**From:** [David and Mary Dexheimer Brackey](#)  
**To:** [All Alders](#)  
**Cc:** [Mayor](#)  
**Subject:** July 19, 2022 Council Meeting  
**Date:** Tuesday, July 19, 2022 6:29:43 AM  
**Attachments:** [Zweig\\_emails.pdf](#)  
[ATT00001.txt](#)  
[Atwood Ave\\_PavementMarking.pdf](#)  
[Atwood Ave\\_Walter St to Cottage Grove Rd.pdf](#)  
[ATT00002.txt](#)  
[ATT00003.txt](#)  
[ATT00004.txt](#)  
[Council\\_presentation.pdf](#)  
[Linda Seemeyer Testimony Madison City Council.pdf](#)  
[ATT00005.txt](#)

Good morning Alders and Mayor. In advance of testimony at this evening's Council meeting , I'd like to provide documentation related to agenda item #4, 72356, Atwood Avenue Reconstruction. Please add these items to the permanent record of this hearing.

City of Madison, Atwood Avenue  
(Walter Street - Cottage Grove Road)  
Local Street  
Dane County

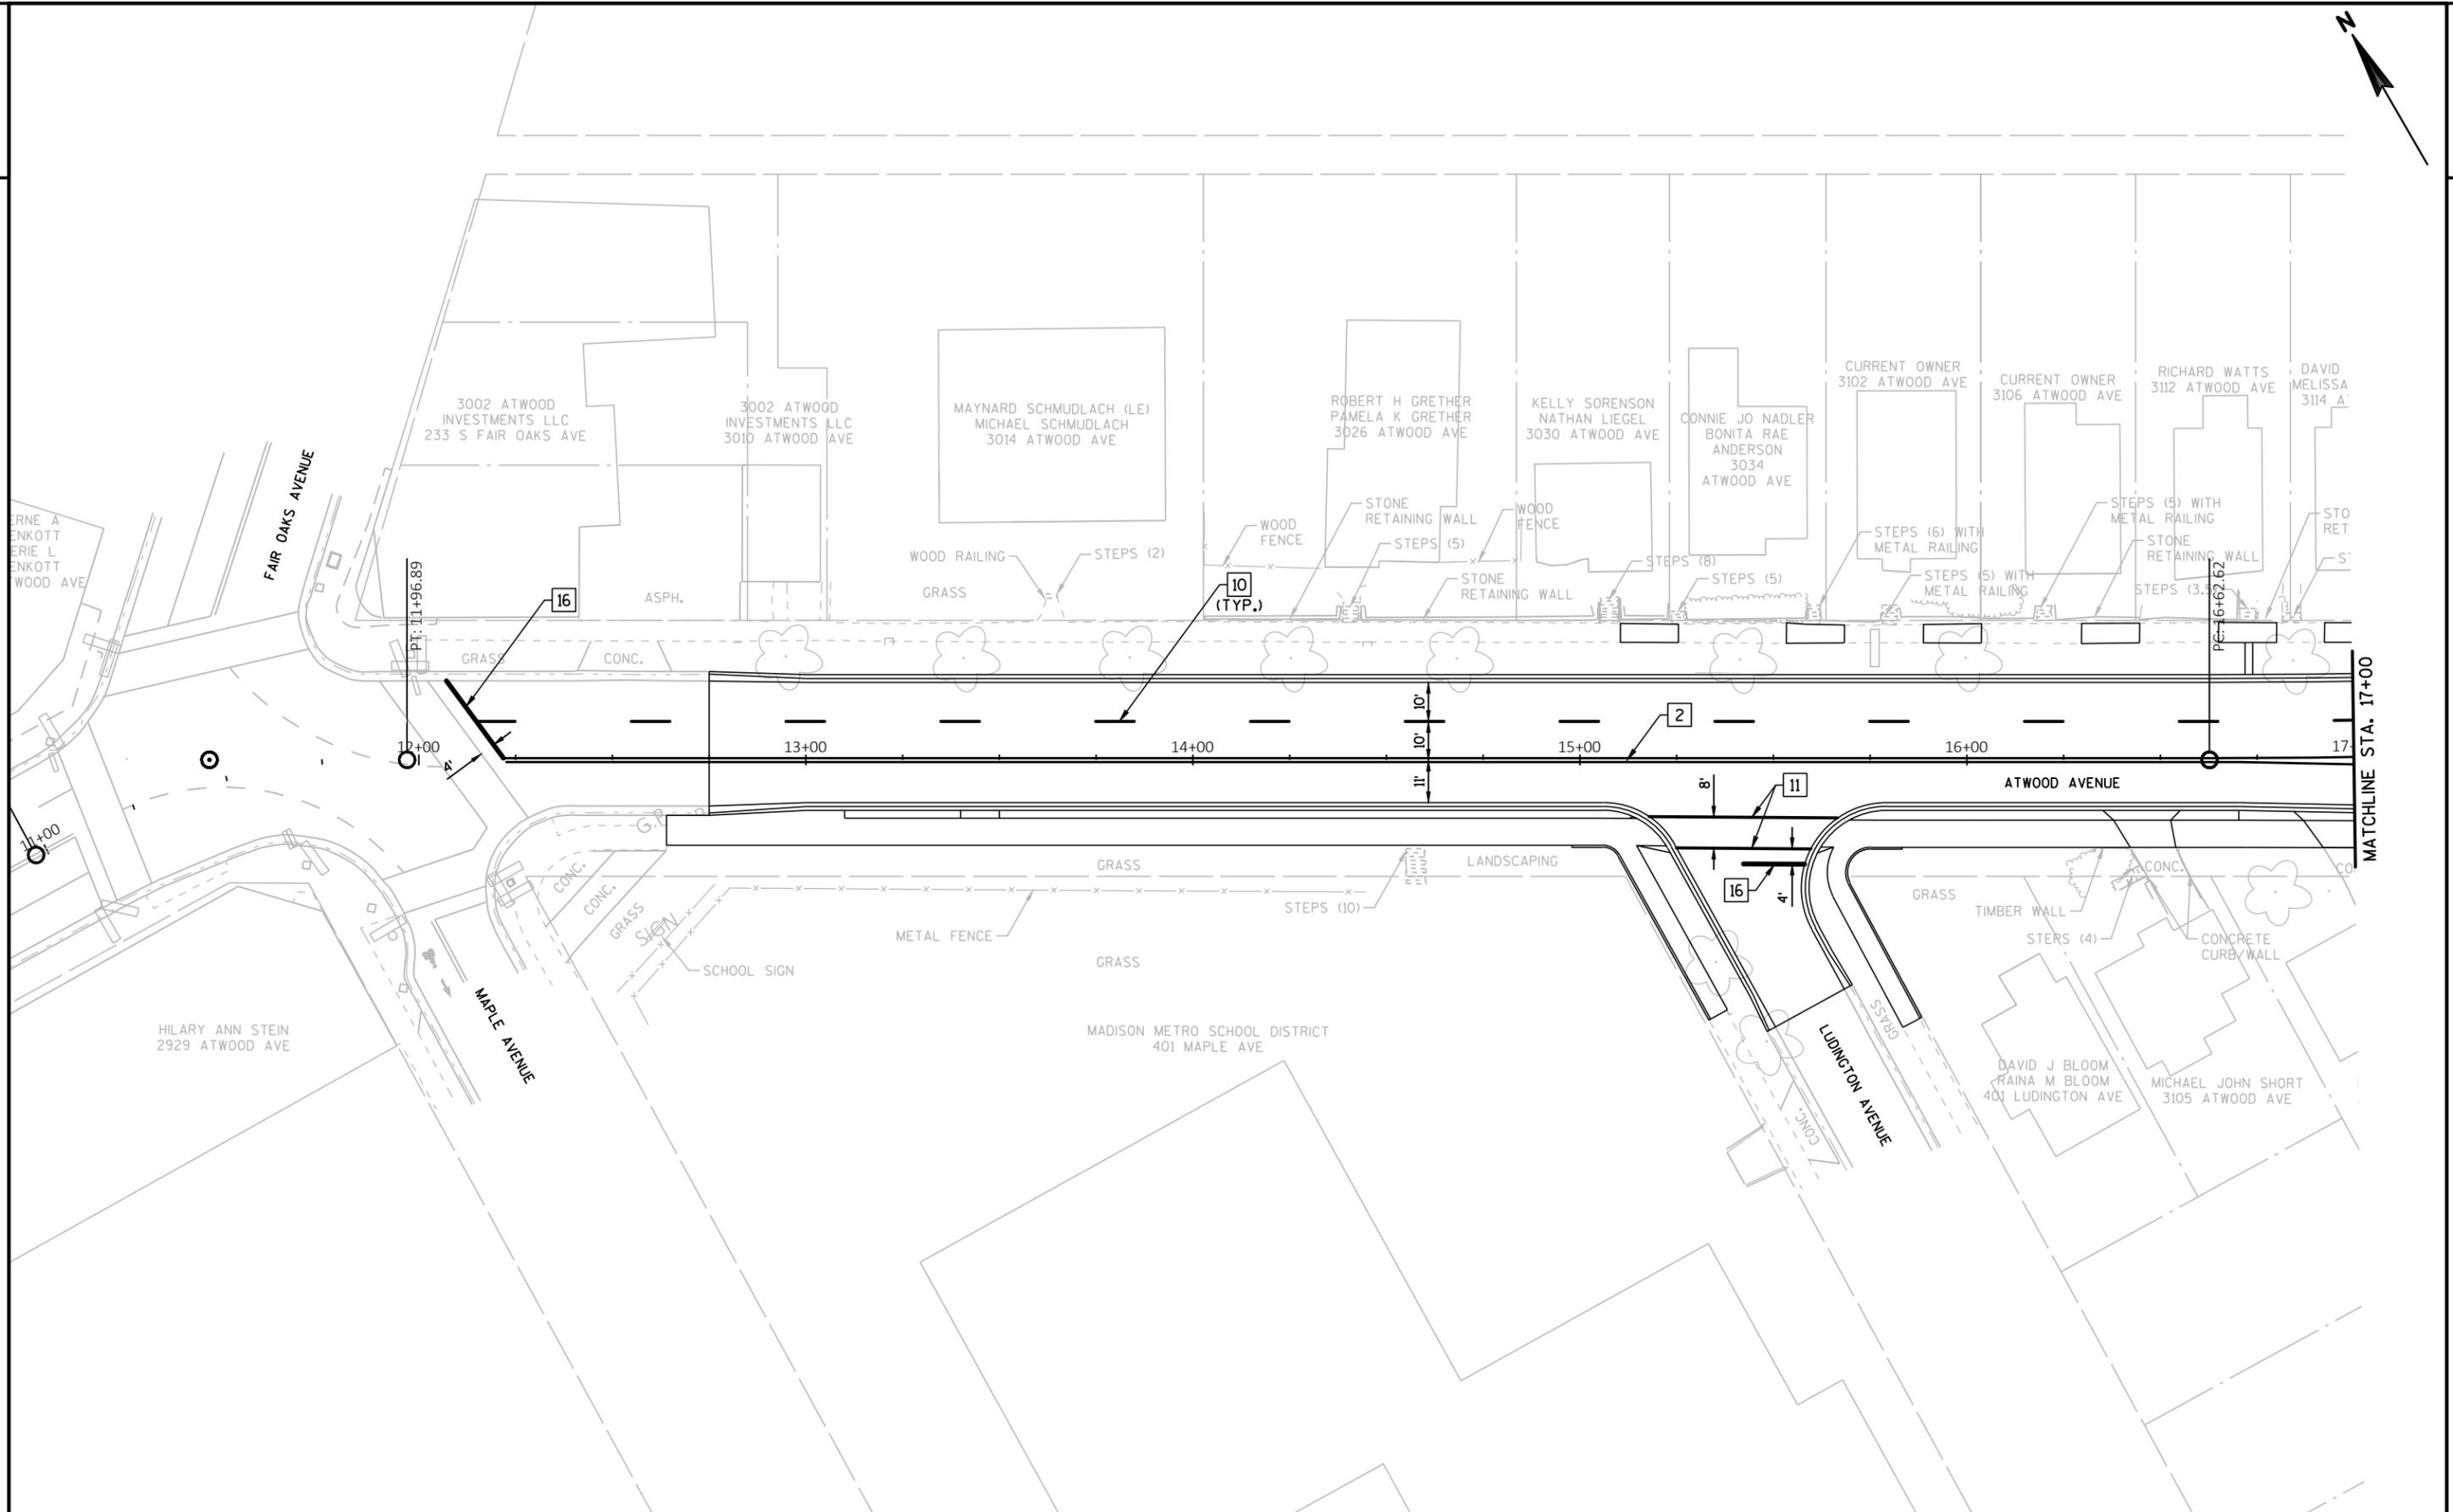
Please take another look at both the existing configuration and what is proposed. Currently, our front gate which is our primary exit from our home is approximately 20 inches from the inside edge of the sidewalk. The current sidewalk is 5' wide. There is a green space approximately 5' wide between the sidewalk and the roadway. In the plan available on line, it is difficult to see exactly where the proposed path interfaces with our property. Does it abut directly with the building? Is there a buffer

between the building and the path as there currently is? The plan shows a green space between the path and the roadway. Could that green space be better utilized by placing it between the building and the proposed path? Could that little strip of green be configured to offer separation between bikes and peds? Either of these options would make it safer for all users. I also notice on the plan that the proposed path is only marked for bike use apparently dedicating all 10' of the path to bicycles and making no accommodation for pedestrians. Is that an oversight on the part of the illustration? I believe there are relatively easy corrections that can be made.

I do not mean to be argumentative but admit that I am baffled as to why the plan calls for converting the on-road bike lane into a shared use path in that single portion of the north side of Atwood. Shared use bike paths are not in the plan for "throughout the Atwood corridor". No where else on the north side of the road is there a shared path except in that single block. Arguably that is the only block which lacks the room to safely house such a path. In my opinion, in a best case scenario, the bike lane would remain on the roadway and a 5' pedestrian sidewalk would be maintained as is.

On another point, the drawing you include in your last email shows the sidewalk trench as both “removed” and “remaining”. For clarification, will the trench remain? It is necessary to the efficient dispersal of rainwater from the building. It should remain.

The proposed back of the path will slide between 0"-6" away the existing back of sidewalk along the building. There will be a small terrace (area between back of curb and front of path). That area acts as a buffer between the vehicles and path users as well it provides space for snow storage, trees, street lighting, and private utility lines (gas manholes, gas valves, electric vaults, & communication vaults). The proposed curb and gutter will move 3'-4' into the street along the property to accommodate the wider path. The path is designated as a shared-use path for all users. The 2 trees along the property will be removed. See screen below of the current plans with further clarification on the lines.

As I mentioned below, the path is sliding away from the existing back of sidewalk along a portion of the building. There is a buffer being created. The sight lines are improving by moving the curb into Atwood, created a path to allow more space for users, improved street lighting, signage, and pavement marking. The proposed terrace along the building varies 4.5' to 6' and will remain. That is the minimum needed for tree plantings, street light placement, curb ramp placement, snow storage, installation of private utility lines, and a buffer between path users and vehicles.

The trench across the sidewalk will be removed and replaced to match the 10' path.
